Product/Process Change Notice (PCN)

<p>PCN Number: PCN_FrqSPXO_20250221</p> <p>Affected Series: WE-SPXO</p> <p>Affected Part Number: See table below</p> <p>PCN Date: 2024-11-21</p> <p>Effective Date: 2025-02-21</p>	<p>Change Category:</p> <p><input type="checkbox"/> Equipment/Location</p> <p><input checked="" type="checkbox"/> General Data</p> <p><input type="checkbox"/> Material</p> <p><input type="checkbox"/> Process</p> <p><input type="checkbox"/> Product Design</p> <p><input type="checkbox"/> Shipping/Packaging</p> <p><input type="checkbox"/> Supplier</p> <p><input type="checkbox"/> Software</p>
<p>Contact: Product Management</p> <p>Phone: +49 (0) 7942 - 945 5001</p> <p>Fax: +49 (0) 7942 - 945 5179</p> <p>E-Mail: pcn.eisos@we-online.com</p>	<p>Datasheet Change:</p> <p><input checked="" type="checkbox"/> Yes <input type="checkbox"/> No</p> <p>Attachment:</p> <p><input type="checkbox"/> Yes <input checked="" type="checkbox"/> No</p>

DESCRIPTION OF CHANGE:

5. Correction of the Product Dimensions:

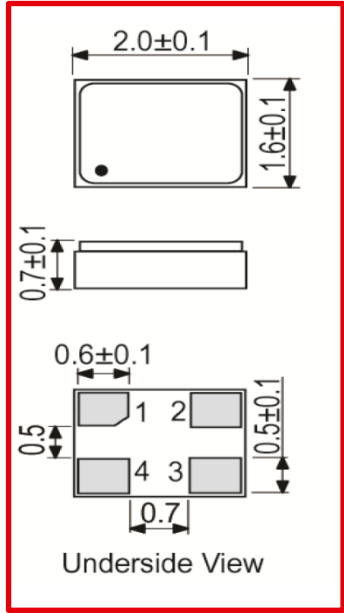
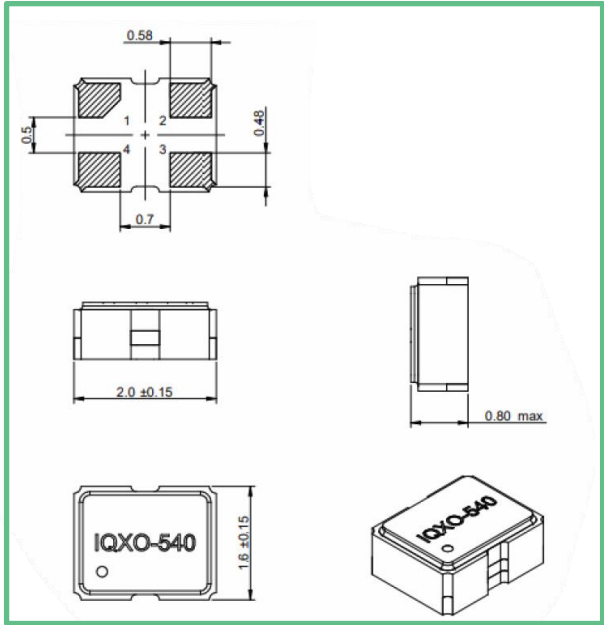
Before	After
Product Dimensions		
L	2.0 ± 0.1	2.0 ± 0.15
W	1.6 ± 0.1	1.6 ± 0.15
H	0.7 ± 0.1	0.80 max

6. Correction of the Solder Pad Layout:

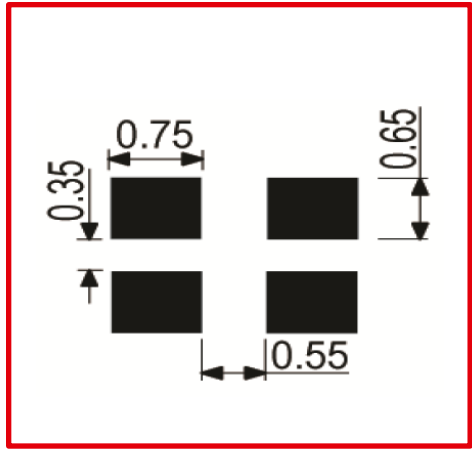
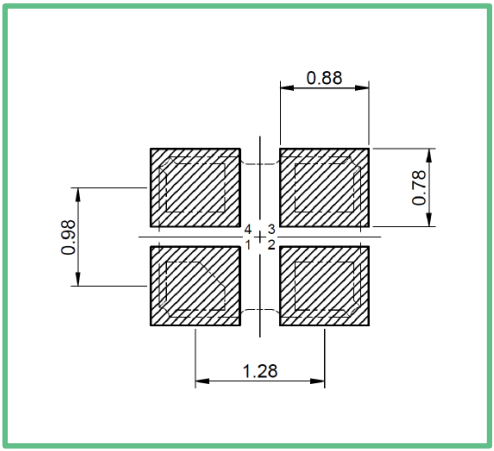
Before	After
Solder Pad Layout
